UN#09-335

Subject: UniStar Nuclear Energy, NRC Docket No. 52-016  
Calvert Cliffs Nuclear Power Plant, Unit 3  
Follow-up Response to Request for Additional Information No. 1001

- Enclosures – 1) RAI 1001 Selected Revised Figures, Calvert Cliffs Nuclear Power Plant Unit 3, Calvert County, Maryland (Hard Copies)  
2) RAI 1001 Selected Revised Figures, Calvert Cliffs Nuclear Power Plant Unit 3, Calvert County, Maryland (Compact Disc)

**Enclosure 1**  
**RAI 1001 Selected Revised Figures**  
**Calvert Cliffs Nuclear Power Plant Unit 3**  
**Calvert County, Maryland**  
**(Hard Copies)**

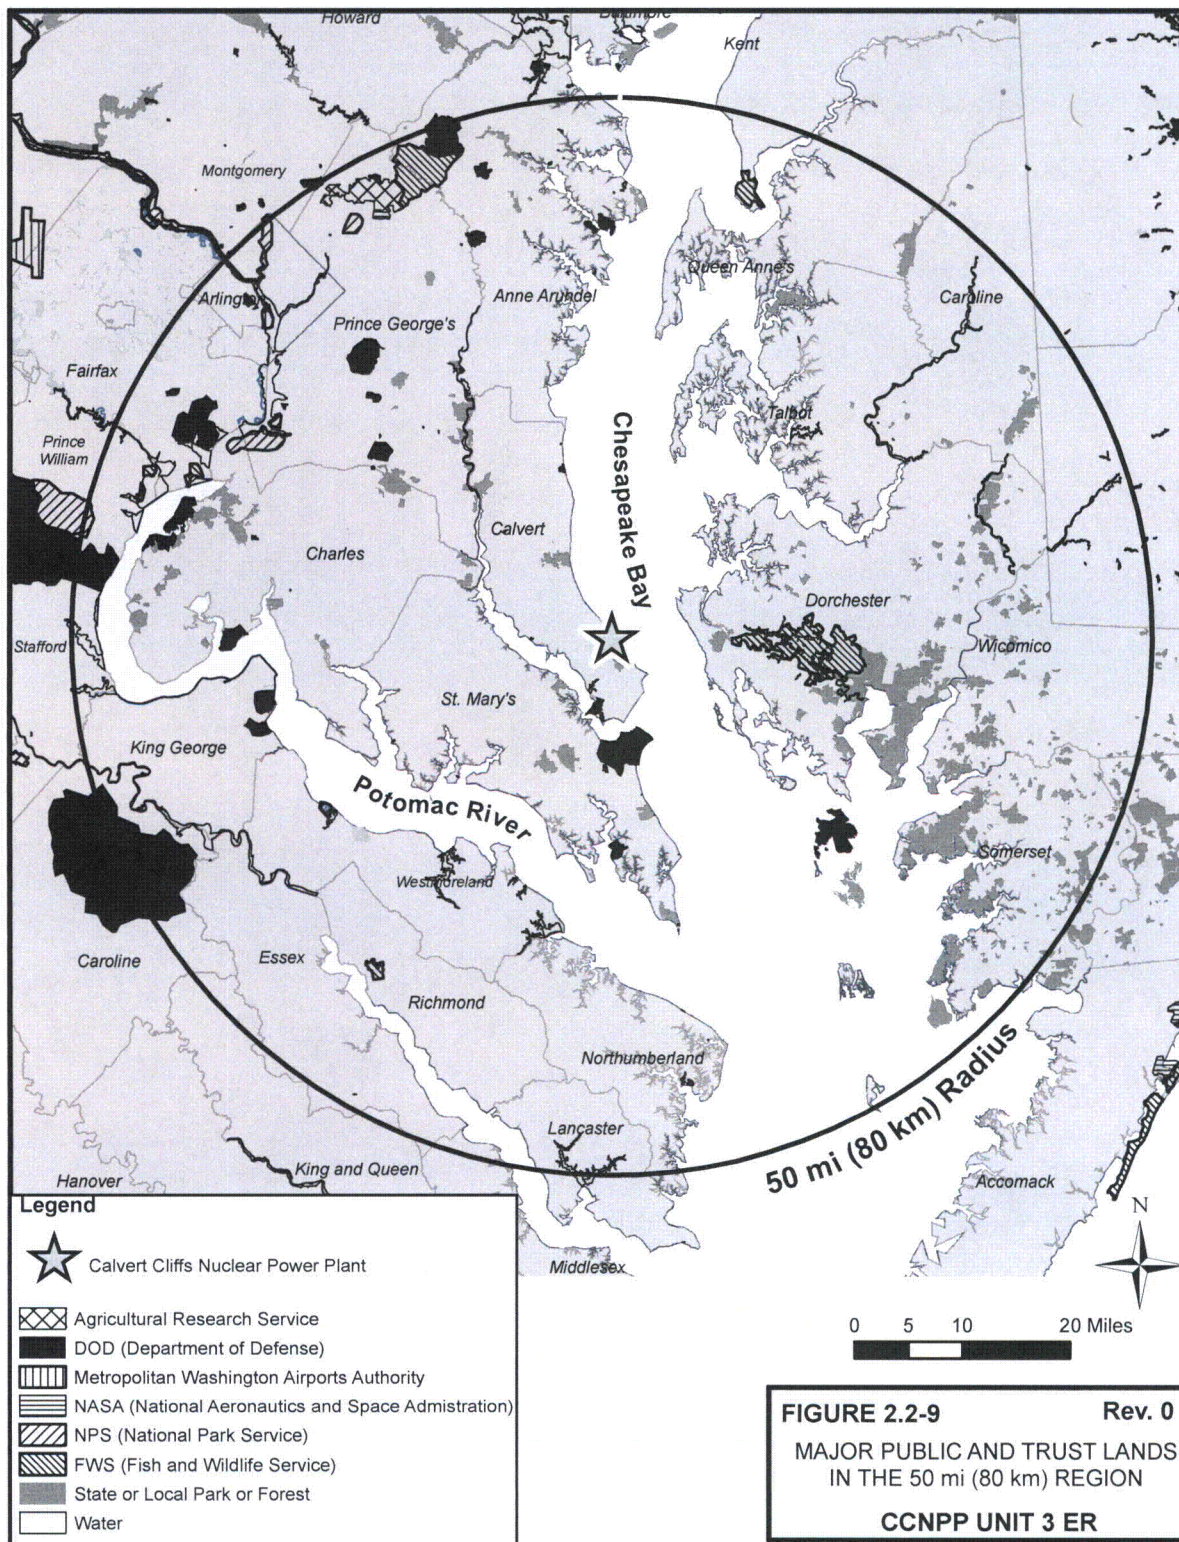
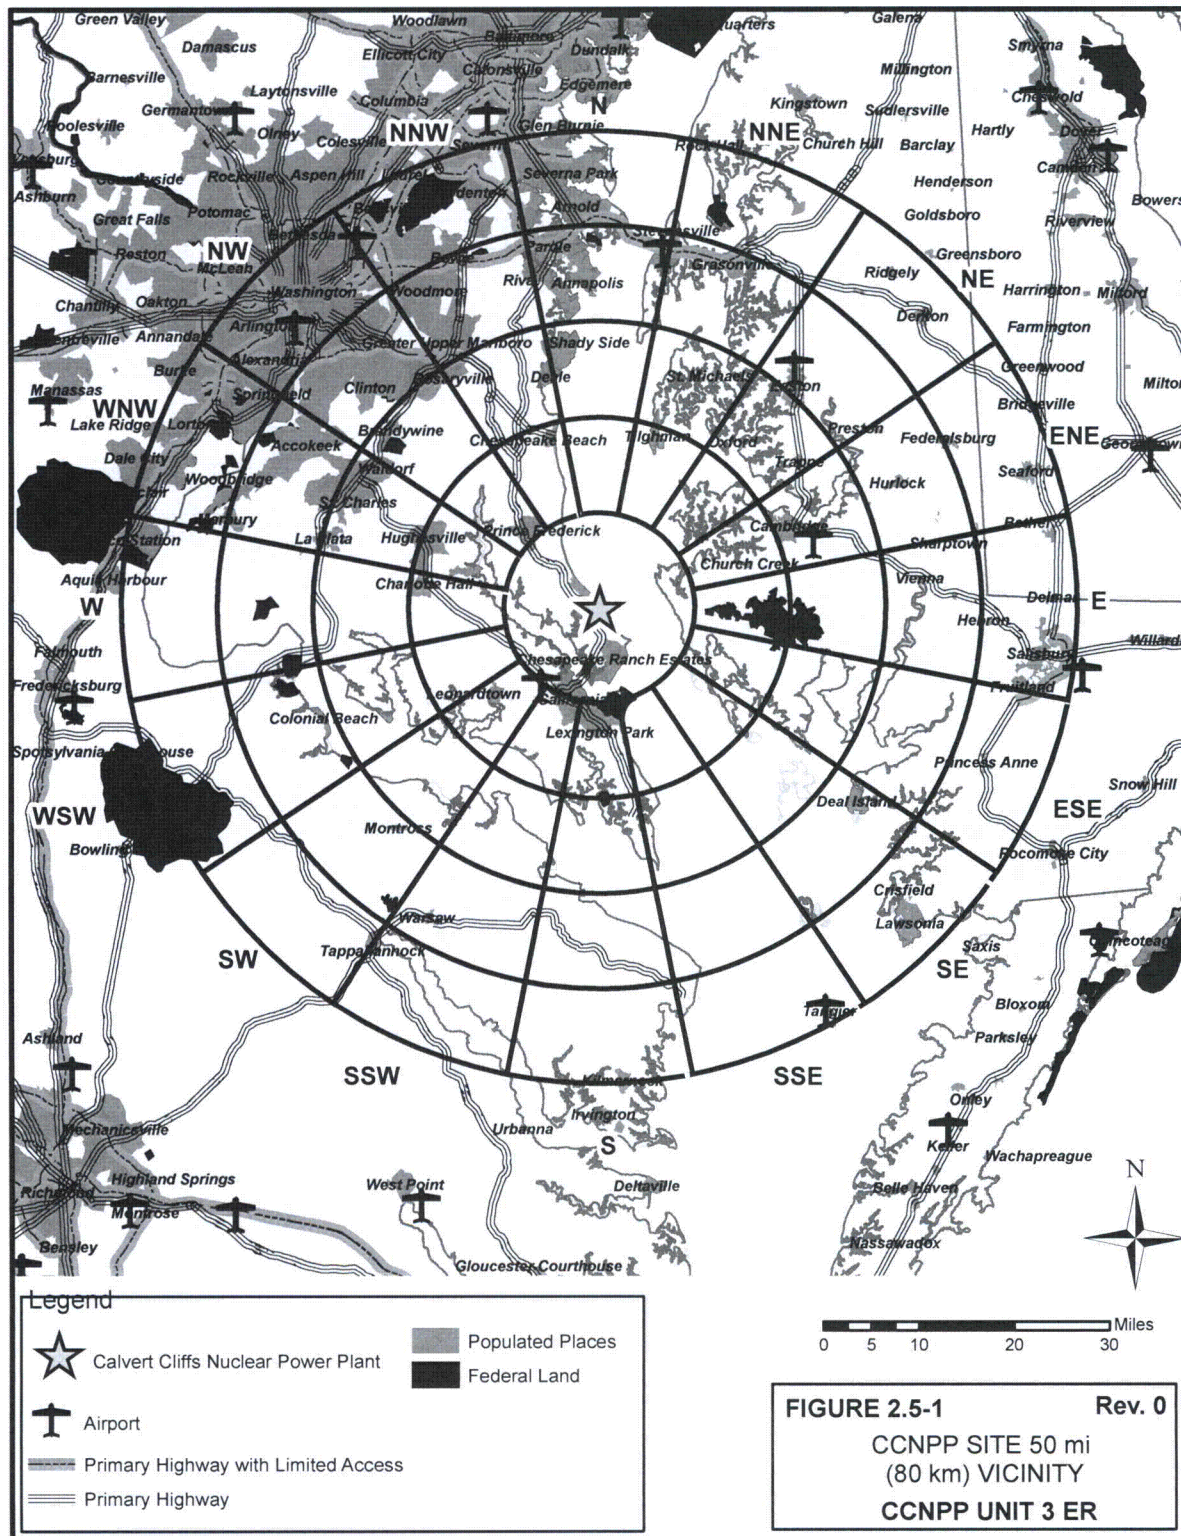
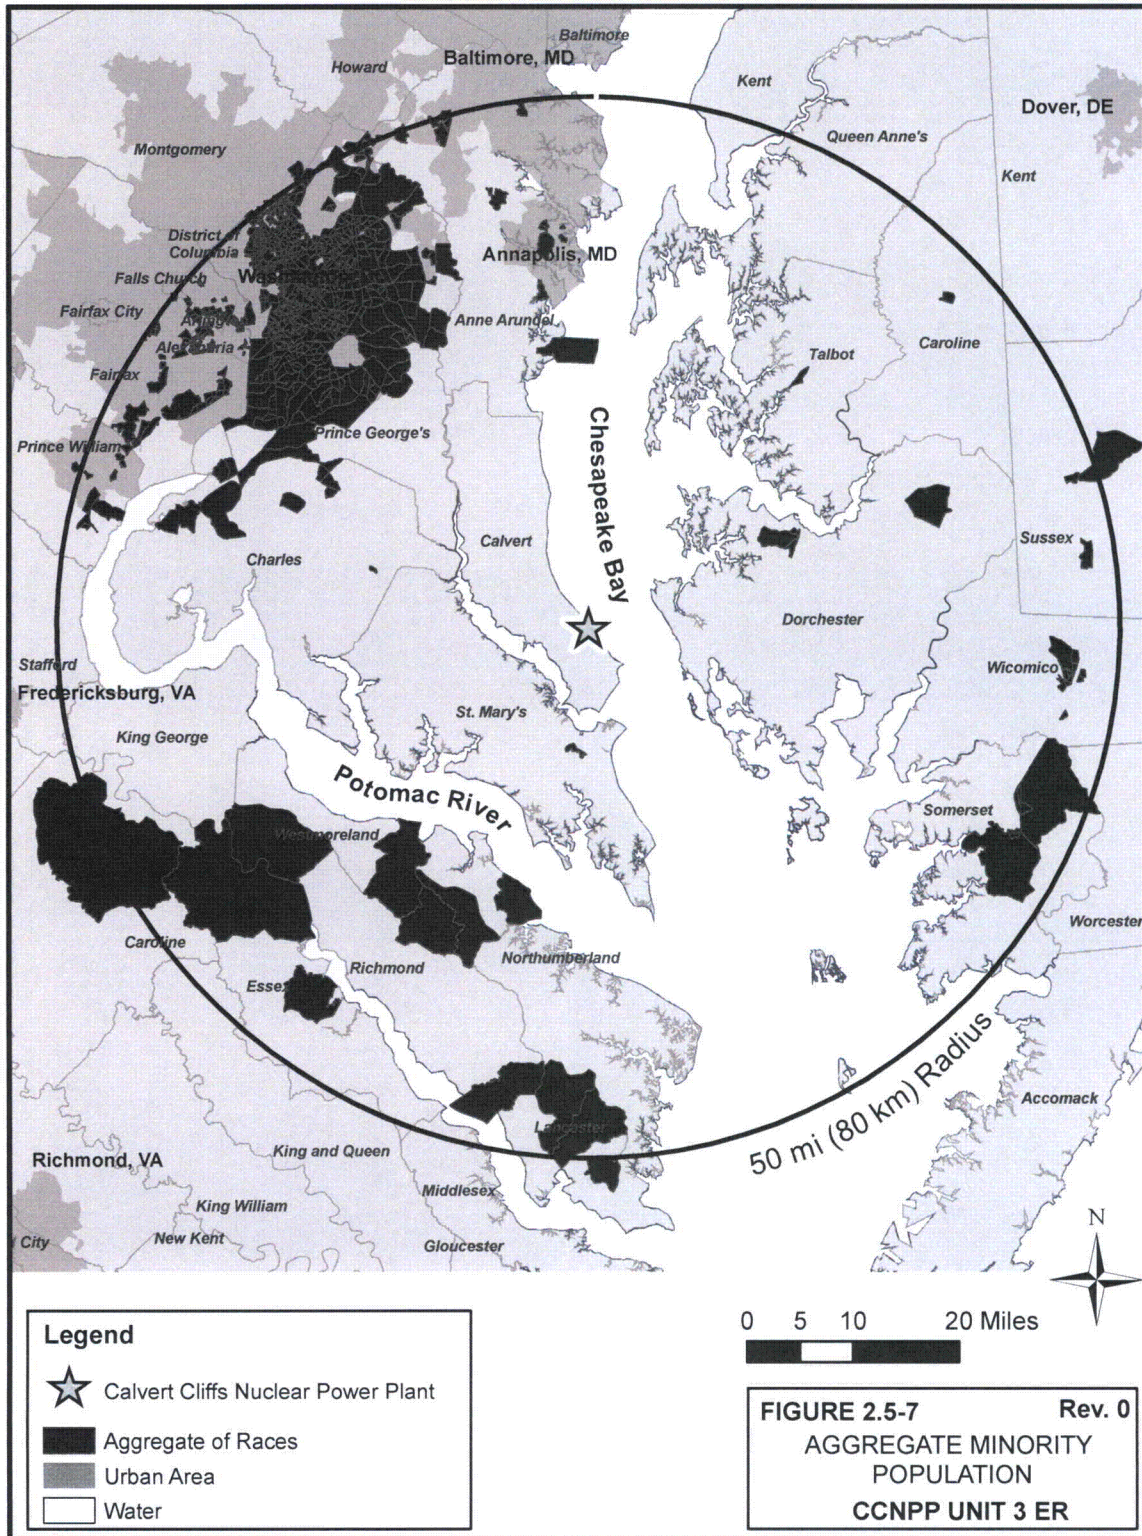
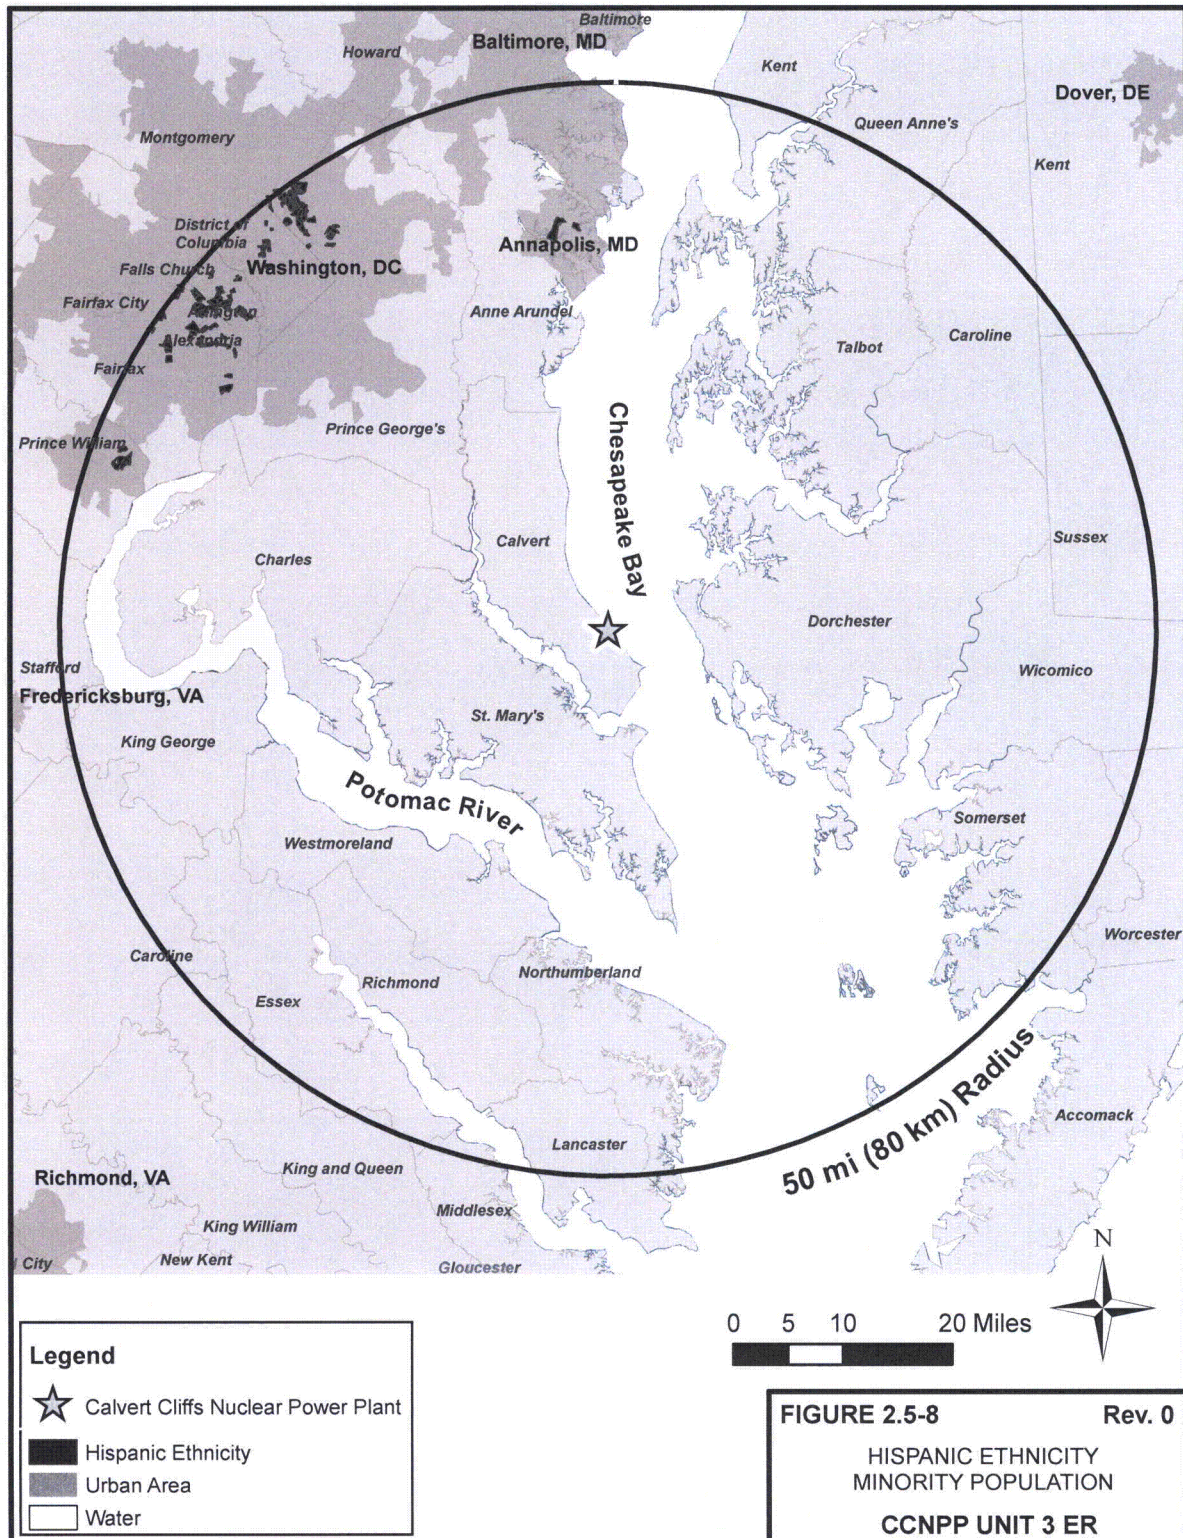
The response submitted for Request for Additional Information (RAI) No. 1001 (Reference 1) included several figures for which the NRC has requested clarification changes. Enhancements were requested for Figure RAI 1001-1 (Figure 2.2-1), Figure RAI 1001-16 (Figures 2.1-1 and 2.2-1), Figure RAI 1001-17 (Figures 2-1 and 2-2), Figure RAI 1001-18 (Thiokol Site Location figure), Figure RAI 1001-20 (Figure 2.2-9), Figure RAI 1001-21 (Figure 2.3-1), Figure RAI 1001-25 (Figure 2.5-1), Figure RAI 1001-27 (Figure 2.5-7) and Figure RAI 1001-28 (Figure 2.5-8).
